# *In-vehicle battery durability e-HDVs*

## *Open Items*

Elena Paffumi, Gian-Luca Patrone  
EVE IWG 72<sup>nd</sup> , web-meeting,  
June 17<sup>th</sup>-18<sup>th</sup> , 2024

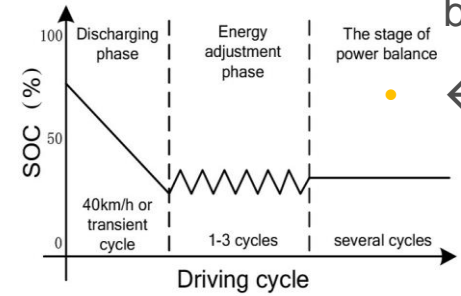
Japan: at least 1500sec ?  
 JE05 : 1830 sec  
 WLTP 4 : 1800 sec  
 WLTP 3 : 1477 sec

Japan: 4 per cent of cumulative UBE

# e-HDV's tests open questions: Break-off criterion EVE IWG 71st

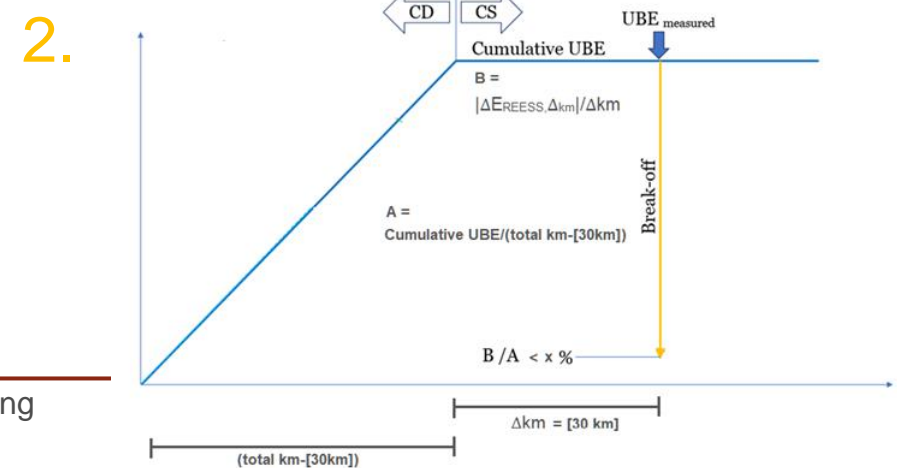
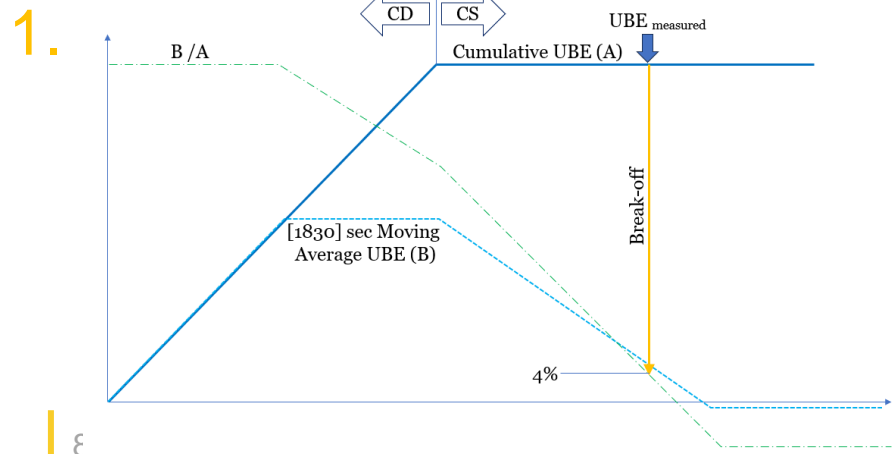
Japan: at least 1500sec ?  
 JE05 : 1830 sec  
 WLTP 4 : 1800 sec  
 WLTP 3 : 1477 sec

Japan: 4 per cent of cumulative UBE

30 km ?

2-3-5 per cent ?

# Method 1a Discharge by standard average speed on a test track

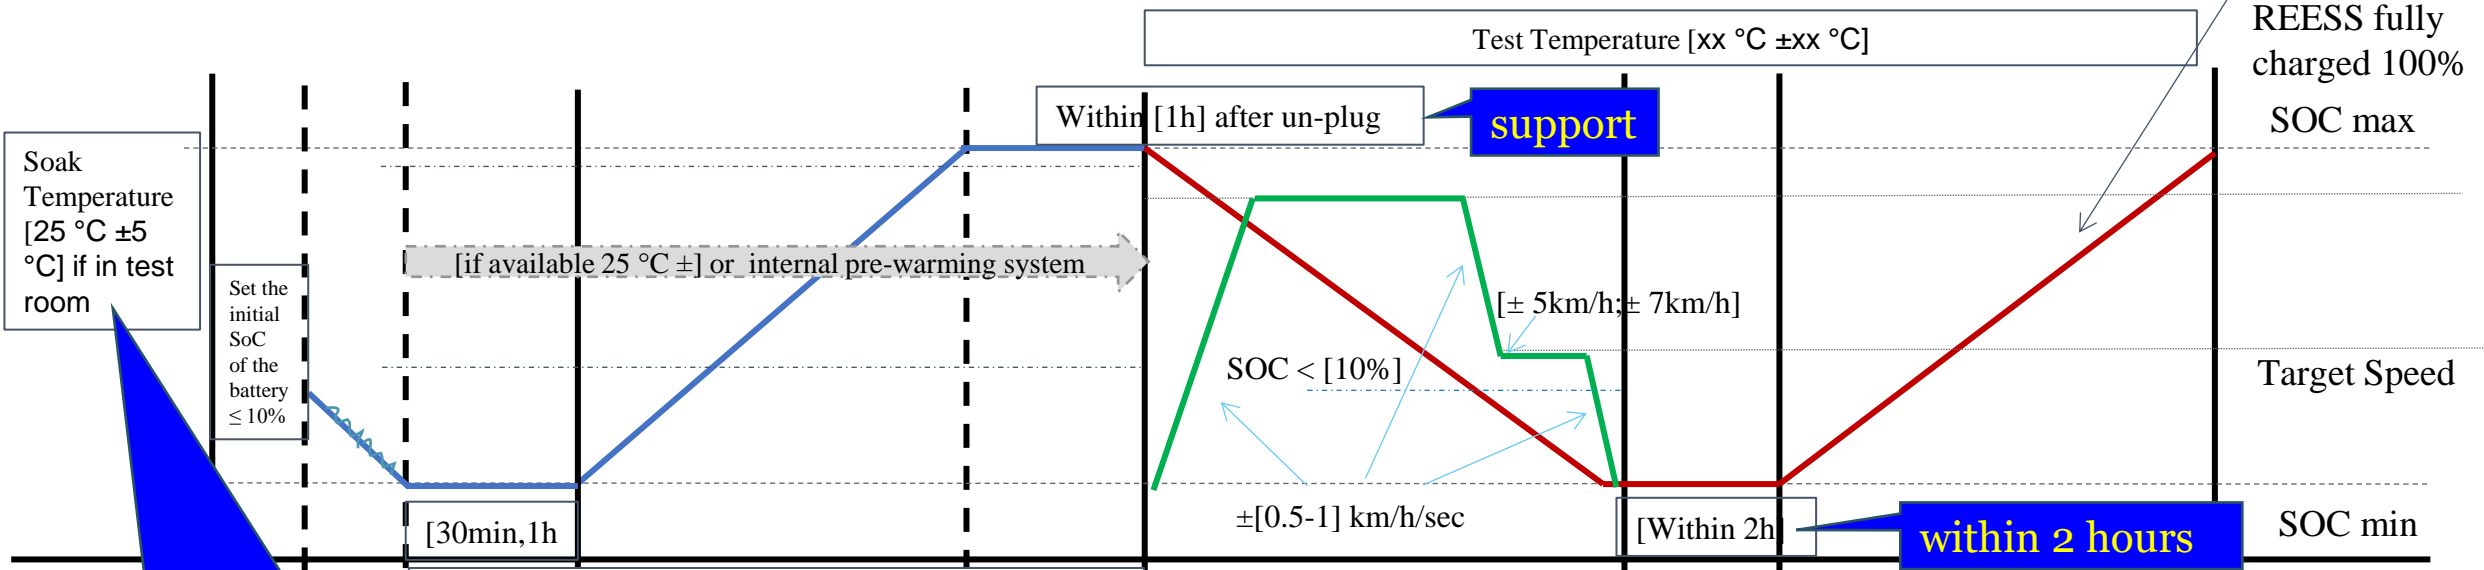
- Range of speed per category per region track
- To leave open the speed for the test and prescribe only the target speed in the last part of the test for which a speed tolerance will be applied
- The last part of the test starts when the SOC < [10%] (to be verified)
- Speed tolerance in last test segment [ $\pm 5\text{km/h}; \pm 7\text{km/h}$ ]
- The acceleration/deceleration during vehicle speed change shall be smooth and accomplished within the range  $\pm[0.5-1]$  km/h/sec
- End of discharge: break-off criterion
- Temperature provision due to cold temperature effect

from RDE moderate conditions (0 to 35 C)?

Japan:  $23$  or  $25 \pm 5 = 18 \sim 30\text{ }^\circ\text{C}$  as an option, wider temperature range is acceptable without any correction if manufacture allows.

not able to support

# Method 1b Discharge by driving on the road with average speed

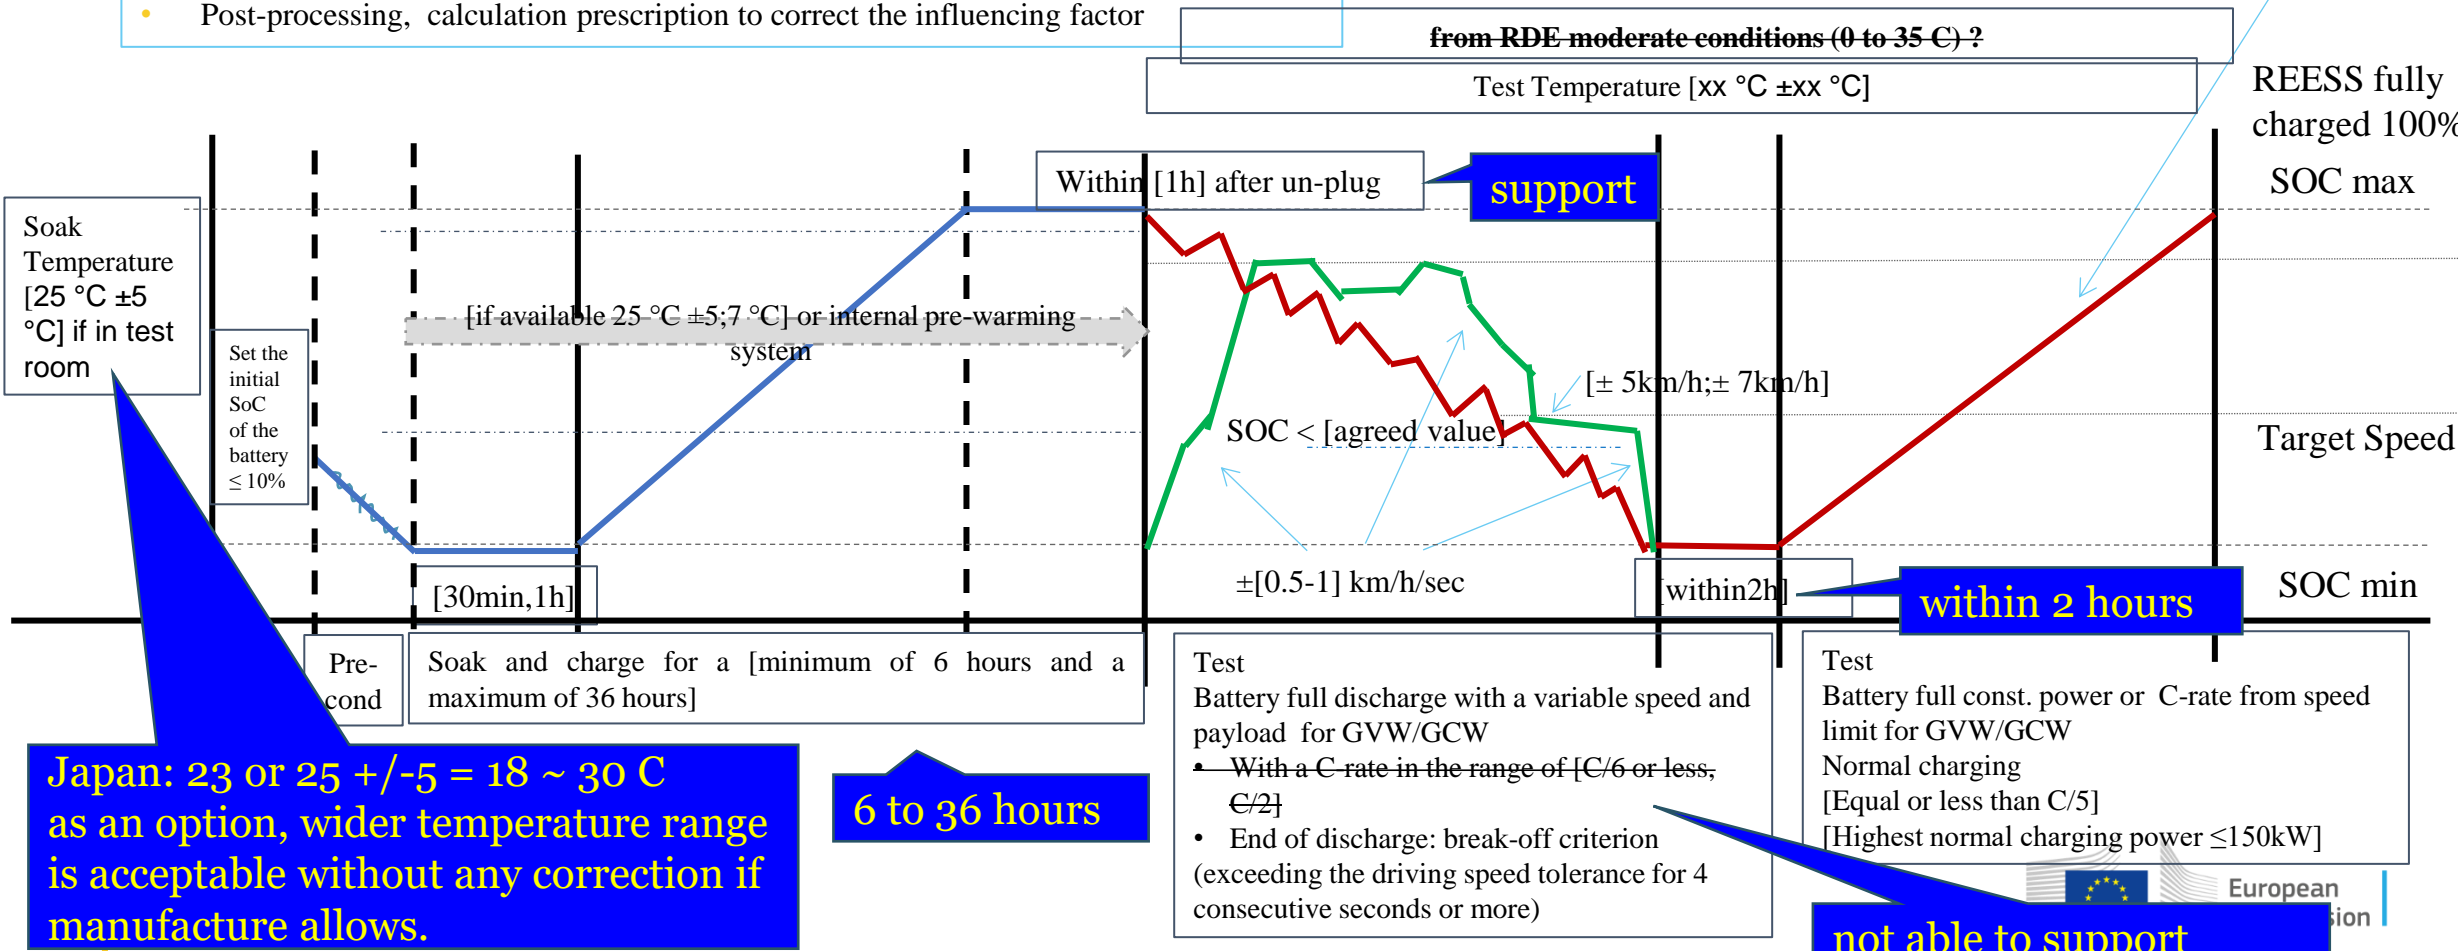
- Range of on-road speed per category per region
- To leave open the speed for the test
- The last part of the test starts with a given SOC level
- Some agreement with local regional authority for SOC minimum level and test
- Same route as type approval or different in accordance with regional authority
- If same routes is used, different provision on minimum SOC level and test
- Speed tolerance? in last test segment ?
- The acceleration/deceleration during speed change shall be as smooth as possible in relation to traffic conditions and safety of driving
- Post-processing, calculation prescription to correct the influencing factor

Japan: 23 or 25 +/- 5 = 18 ~ 30 C as an option, wider temperature range is acceptable without any correction if manufacture allows.

# Method 2 bidirectional charging system available

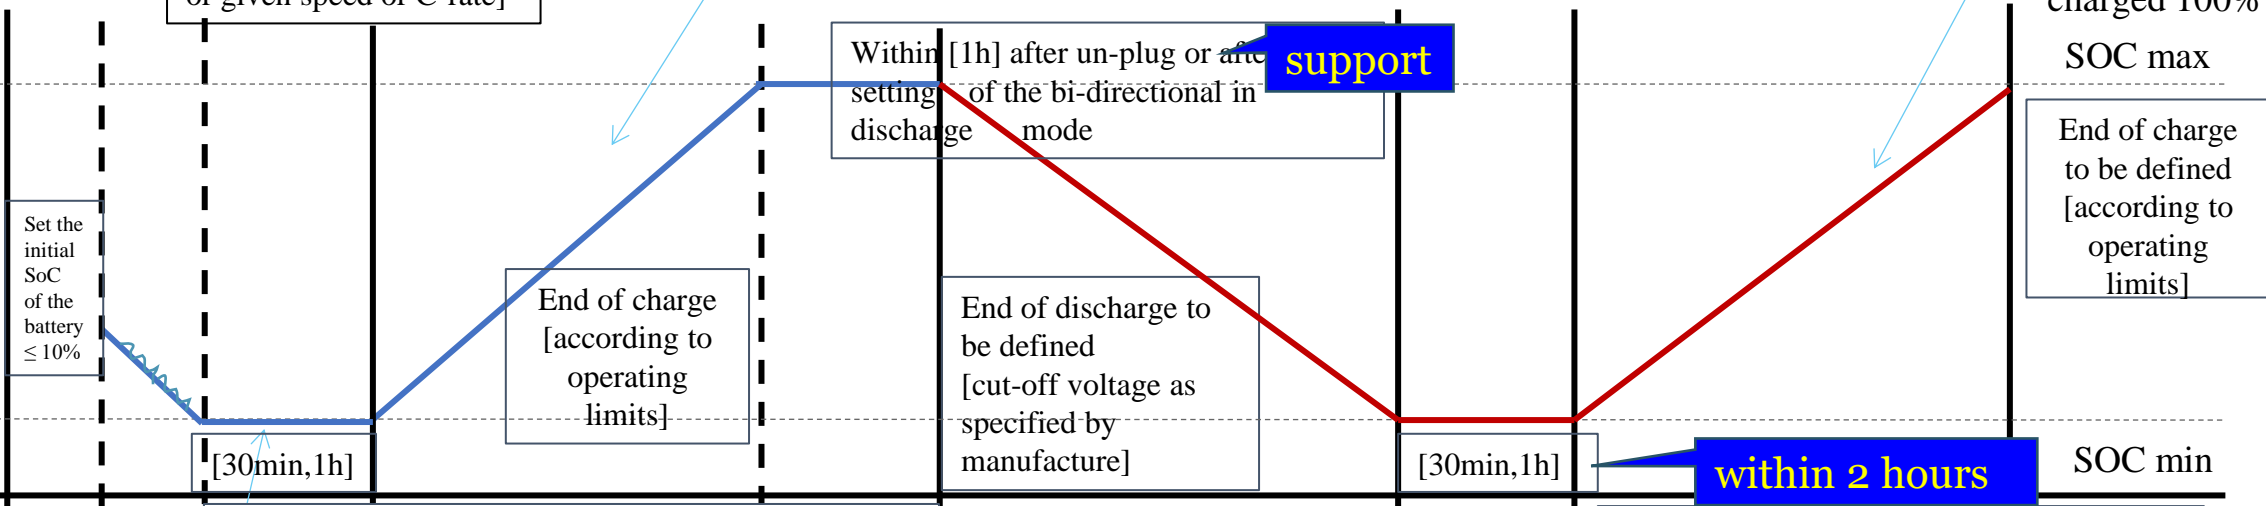
within 0 ~ 35 C

follow manufacture recommendation

within 2 hours

not able to support

End of discharge to be defined for bi-directional charging test [Cut-off voltage]
